To all users of the following software products: syngo.via RT Image Suite

Customer Safety Advisory Notice MR020/20/S

Subject: Potential incorrect geometry in resulting Synthetic CT images created by the software option "Synthetic CT" of syngo.via RT Image Suite when using input MR images

Fig. 1: Comparison of Synthetic CT image calculated from axial acquisition to Synthetic CT image calculated from coronal direction.

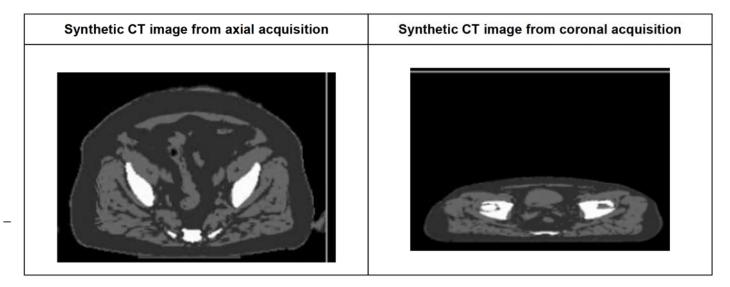
If the user modifies for any reason (e.g. reduction of artifacts) the original image orientation of a standard MR protocol to acquire images in a different orientation for further processing in "Synthetic CT", the software does not recognize the adapted acquisition plane. This may result in images with wrong geometry. When this distortion remains unnoticed and the images are subsequently exported to a treatment planning system (TPS), it cannot be excluded that this results in an incorrect calculated radiation treatment plan. The occurance of this case is very unlikely and has never been reported so far.

An example of a visibly distorted image is shown in Fig. 1.

- 1. Use MR data acquired in axial orientation as input for Synthetic CT calculation only.
- 2. Use protocols validated by Siemens Healthineers only.
- 3. In any case, always perform a pretreatment verification to compare the actual treatment position with the target position.

The described issue will be solved with a service pack for software versions

- Syngo.via server: syngo.via VB30 with update SY039/20/S and syngo.via VB40 with SY040/20/S
- MAGNETOM systems: NUMARIS X A20A with service pack 04 provided with MR021/20/S.
